Access Compliance Report

Public Rights-of-Way

Intersection ID: 13301	Main Street: S_TRYON_ST	Cross Street: W_CATHERINE_ST	Location:	N
ADA ID: 4353DD478971	Ramp Type: PerpDiag	Initial Pass/Fail: Fail	Overall Compliance: No	Severity Score: 37.5

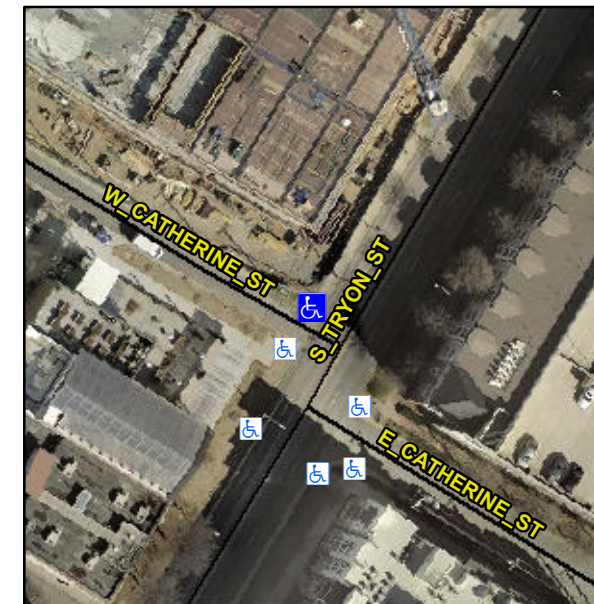
Not Found, R304.2.2, R304.5.3

Compliance	Description	Data	Compliance	Description	Data
N/A	Ramp Length (in)	58.0	No	Ramp Slope (%)	17.9
Yes	Ramp Width (in)	48.0	No	Ramp XSlope (%)	5.7
N/A	Flare Type LT	N/A	N/A	Flare Type RT	N/A
N/A	Flare Slope LT (%)	N/A	N/A	Flare Slope RT (%)	N/A
N/A	Flare Traversable LT?	N/A	N/A	Flare Traversable RT?	N/A
N/A	Landing Length (in)	N/A	N/A	DWS Provided?	N/A
N/A	Landing Width (in)	N/A	N/A	DWS Contrast?	N/A
N/A	Landing Slope (%)	N/A	N/A	DWS Length (in)	N/A
N/A	Landing X Slope (%)	N/A	N/A	DWS Full Width?	N/A
N/A	Landing Curb? (Y/N)	N/A	N/A	DWS Offset (in)	N/A
N/A	Shared Landing?	N/A			
N/A	Gutter Ponding?	N/A	N/A	Gutter Slope (%)	N/A
N/A	Gutter Lip Ht (in)	N/A	N/A	Gutter X Slope (%)	N/A
N/A	Painted X Walk1?	No	N/A	Painted X Walk2?	No
	X Walk 1 Direction	To SW		X Walk 2 Direction	To SE
N/A	X Walk 1 Width (in)	N/A	N/A	X Walk 2 Width (in)	N/A
	X Walk 1 Slope (%)	2.3		X Walk 2 Slope (%)	2.6
	X Walk 1 X Slope (%)	2.5		X Walk 2 X Slope (%)	1.2

Remove & Replace Curb Ramp With Two New Directional Ramps or Equivalent.
